Technical Service Bulletin

**LIGHT RESISTANCE AND/OR UNUSUAL NOISE WHEN TURNING
STEERING WHEEL LEFT OR RIGHT**

Bulletin No.: 06-002/25

Last Issued : 11/13/2025

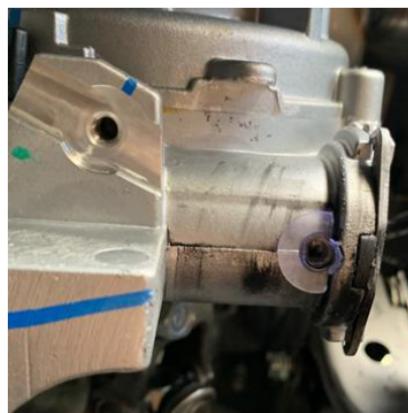
5. Prepare the grease tube, **guide cap** and **tube wringer**.
6. Start the engine.
7. Turn the steering wheel to the **LEFT** lock position.
8. **Install the rubber cap in the hole. The circumferential direction is determined by the shape of the rubber cap.**

NOTE: The rubber cap in the photo is clear, but it is actually black in color.

9. **Cut 6 mm off the tip of the grease tube.**

10. **Set the grease tube into the rubber cap. Insert the grease tube into the rubber cap lightly until it bottoms out.**
